**SUBJECT: DIABLO CANYON POWER PLANT UNIT NOS. 1 AND 2 – STAFF
ASSESSMENT OF RESPONSE TO 10 CFR 50.54(f) INFORMATION REQUEST
– FLOOD-CAUSING MECHANISM REEVALUATION (CAC NOS. MF6039 AND
MF6040: EPID L-2015-JLD-005)**

STAFF ASSESSMENT BY THE OFFICE OF NUCLEAR REACTOR REGULATION

RELATED TO THE FLOODING HAZARD REEVALUATION REPORT

DIABLO CANYON POWER PLANT, UNIT NOS. 1 AND 2

Figure 3.1-1. Key Hydrologic Features of Interest at the Diablo Canyon Site in Relation to Important Power Reactor Features and Topography (PG&E, 2016b)

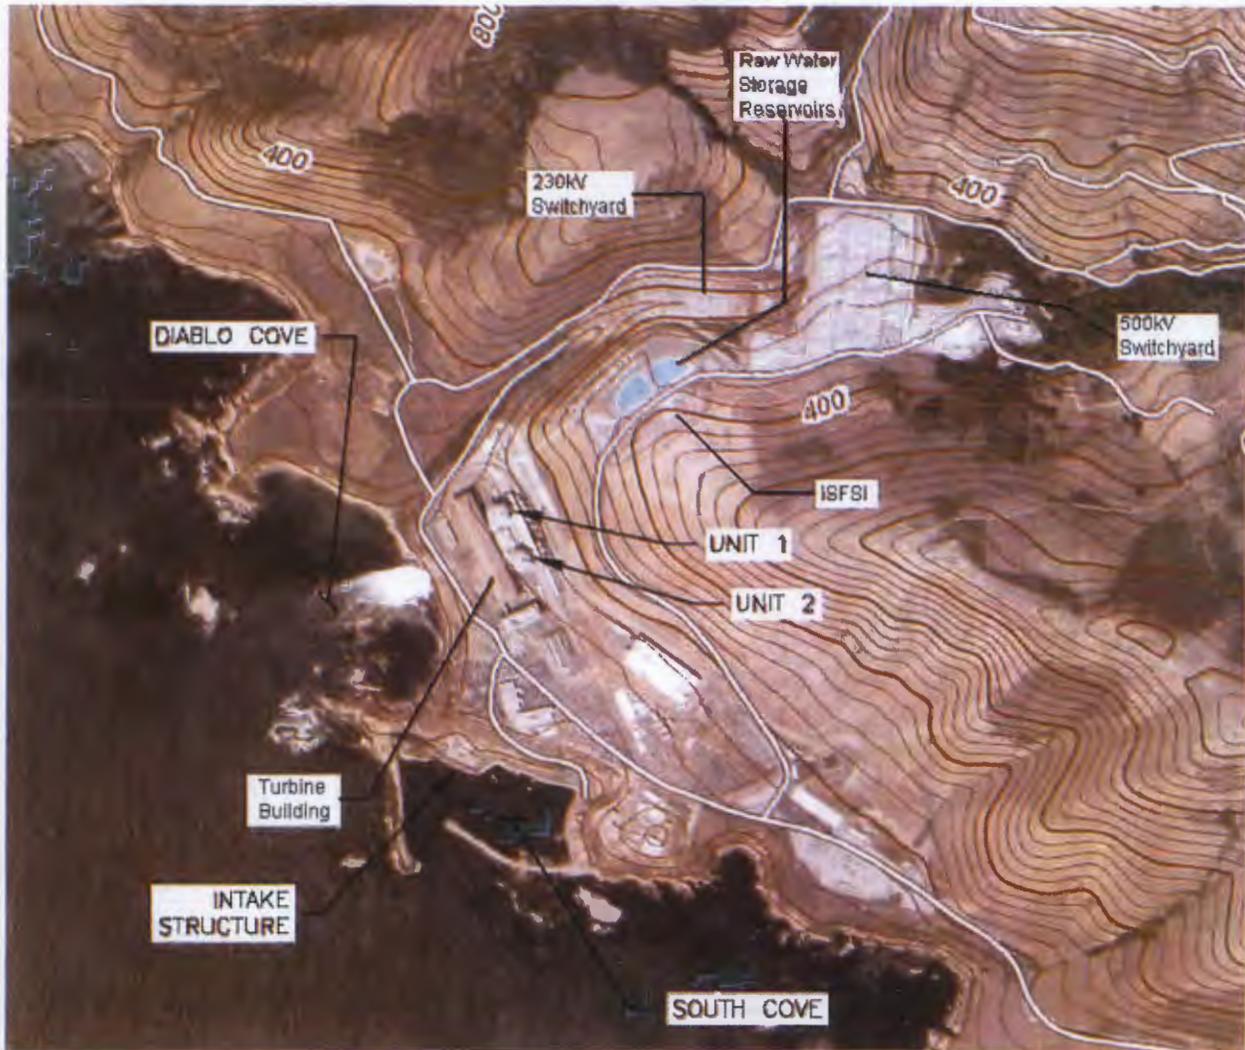
The reactor site physically occupies a marine coastal terrace that overlooks the Pacific Ocean (see Figure 3.1-1). The Diablo Canyon site extends over 750 acres (ac) of which about 12 ac is occupied by the powerblock. At its widest point, the width of the kidney-shaped powerblock is about 1,000 ft. The topography of the powerblock is such that the grade of the site dips (slopes) away from major Diablo Canyon structures principally toward the Pacific Ocean and to a lesser extent the Diablo Creek. The seaward-facing edge of the Diablo Canyon site is a near-vertical cliff. Piping associated with the safety-related Auxiliary Salt Water (ASW) system is protected by man-made gabion mattresses at the lower elevations.

Figure 3.2-1. Computational Domain for the Diablo Canyon LIP FLO-2D Analysis (PG&E, 2016a)

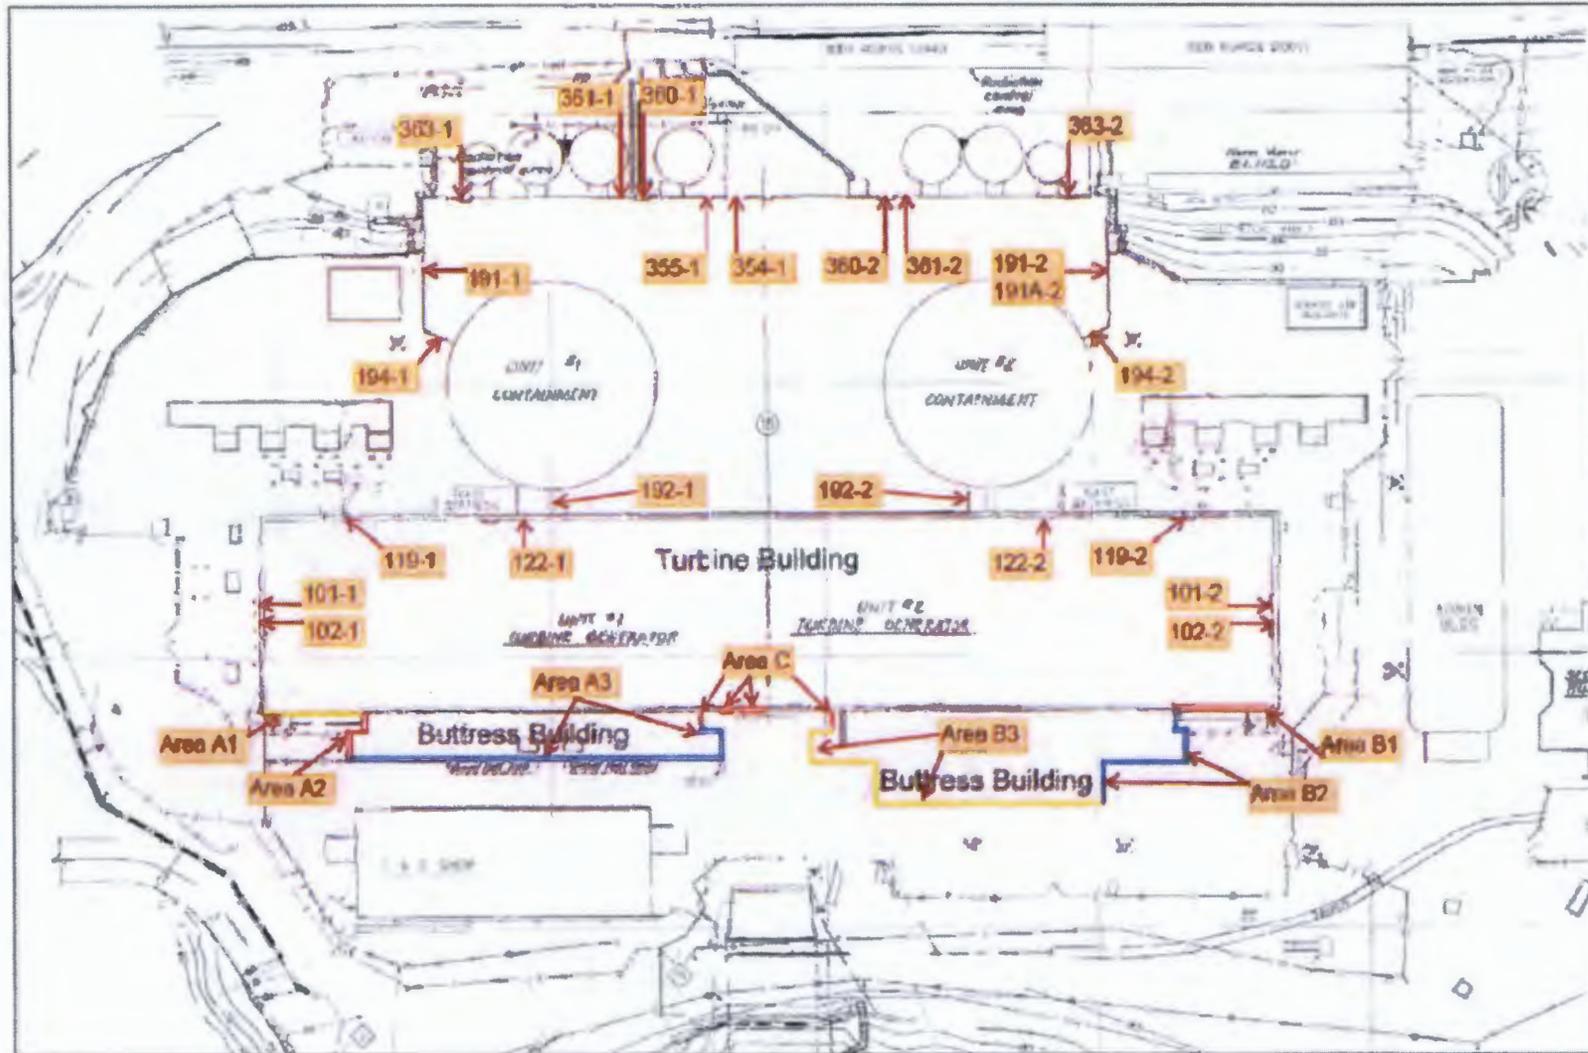
Ground-surface elevations across the Diablo Canyon site vary from about 308 ft to about 42 ft NAVD88 (north to south). The elevations reported there are based on an existing licensee-prepared topologic map of the site with 0.5-ft contours. The licensee also used a digital elevation map based on a Light Detection and Ranging (LiDAR) survey prepared for the State of California to provide topographic coverage for the area between the eastern margin of the powerblock to the highland area containing the RWSRs and the switchyards. The horizontal resolution of those LiDAR data were 1 meter or about 3 ft. The licensee relied on a U.S. Geological Survey (USGS) quadrangle imagery map to extract the land-use information for the site. The licensee integrated the LiDAR data with topographic data and land-use data using a Geographic Information System tool to develop raster point elevations which were in turn used to generate grid cell elevations in the FLO-2D computer model. The computational domain of the licensee's FLO-2D model is the shaded area depicted in Figure 3.2-1.

elevations to each grid cell consistent with the data sources described in Section 3.2.1. The boundary of the LIP model is depicted in Figure 3.2-1.

In reviewing the licensee's FLO-2D model, the NRC staff noted that the eastern boundary of the model ended at the access road leading to the RWSRs, the switchyards, and the Independent Spent Fuel Storage Installations. To the east of that road is an area dominated by a topographic promontory that overlooks the Diablo Canyon site (Figure 3.1-1). Moreover, based on an inspection of the USGS topographic map that included the power plant site, the NRC staff noted that there is the potential for sheet flow associated with this promontory area to travel over the access road and continue in the direction of the Diablo Canyon powerblock. To establish whether the higher topographic area to the east of the access road introduces additional precipitation-related sheet flow into the powerblock yard, the NRC staff performed an additional FLO-2D computer simulation that included the flow generated from this expanded area. Based on a review of the USGS topographic map, the NRC staff delineated two new sub-basins, designated Sub-basins 1 and 2, to the east of the access road (Figure 3.2-2). The surface areas for each of these sub-basins is, respectively, 13.4 ac and 13.1 ac; this additional area expanded the total size of the modeling area by about 34 percent. Based on an inspection of the topography, the staff would expect that runoff from the Sub-basin 1 would flow directly into the powerblock area whereas the disposition of runoff associated with Sub-basin 2 was less clear.

To account for the additional sub-basin inflow, the NRC staff modified the licensee's FLO-2D LIP model by adding 10 inflow nodes along the eastern boundary at the access road location, as shown in Figure 3.2-2. The HEC-HMS simulated sub-basin flow rates were distributed evenly to 10 inflow nodes.

Figure 3.2-3. Location of Buildings and Facilities with Door Locations Identified for Monitoring of LIP Flood Hazards (PG&E, 2016a)

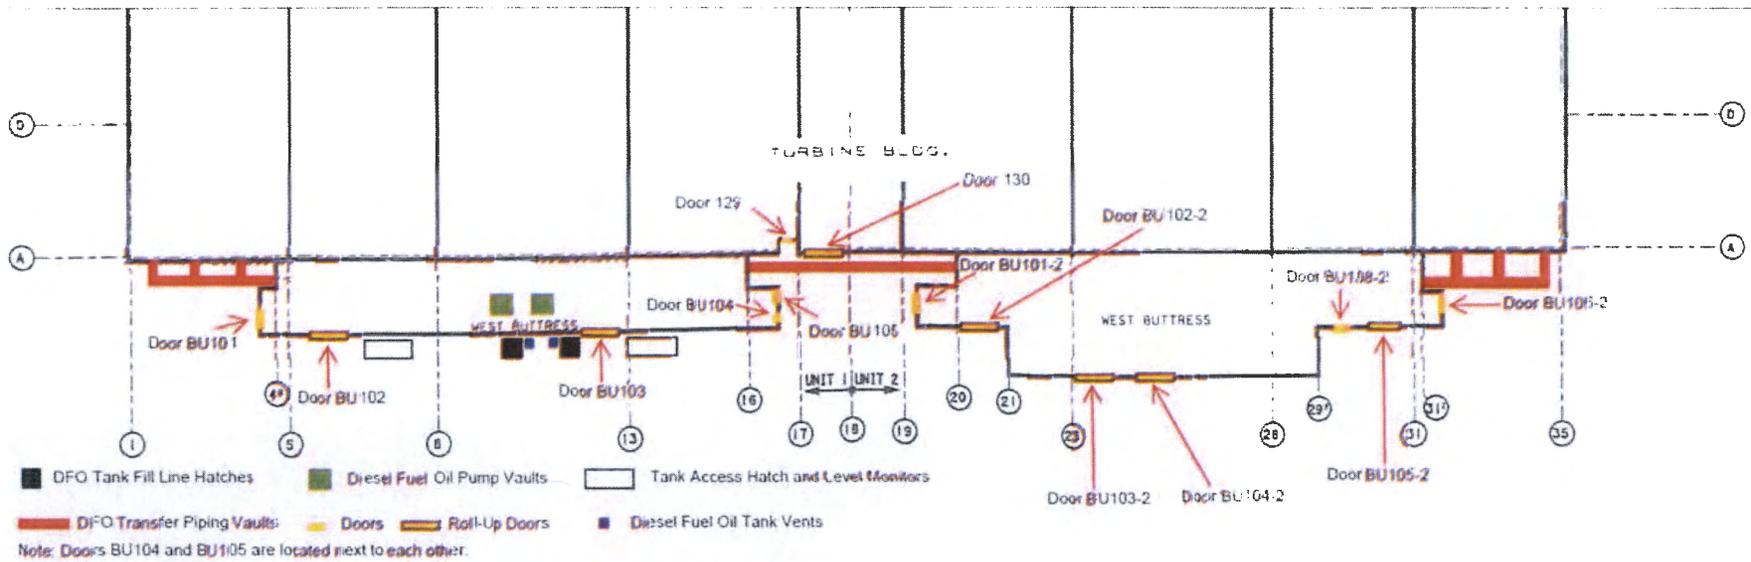
The licensee identified multiple potential flow path locations around each of the two reactor units and other structures by which flood water could potentially affect plant safety. In Table 3-5 of its FHRR (PG&E, 2016b), the licensee identified a variety of locations, including both safety-related and non-safety-related buildings, for which the CDB was exceeded by the reevaluated LIP hazard elevation. Key monitoring locations around the two reactor units and turbine building identified by the licensee are shown in Figures 3.2-3 and 3.2-4. Table 3.2-1 summarizes the results of the licensee's LIP flood reevaluation. The licensee reported the reevaluated flood hazard as a maximum flood depth ranging from about 0.1 ft to 0.7 ft at the locations identified (PG&E, 2106). The licensee compared the estimated flood depth to the inlet height of doors and hatches at each of the potential pathway locations. The licensee reported that maximum flood depths were greater than some door/hatch inlet heights for safety-related structures. The licensee also acknowledged that there was a temporal aspect to those flood depths that varied by location when the drainage characteristics and geometry of the powerblock were taken into account. The maximum inundation depth of 0.7 ft was expected to occur at the monitoring location Door/Unit #192-1, between the Unit 1 Containment and Turbine buildings with a maximum WSE of 88.2 ft NAVD88.
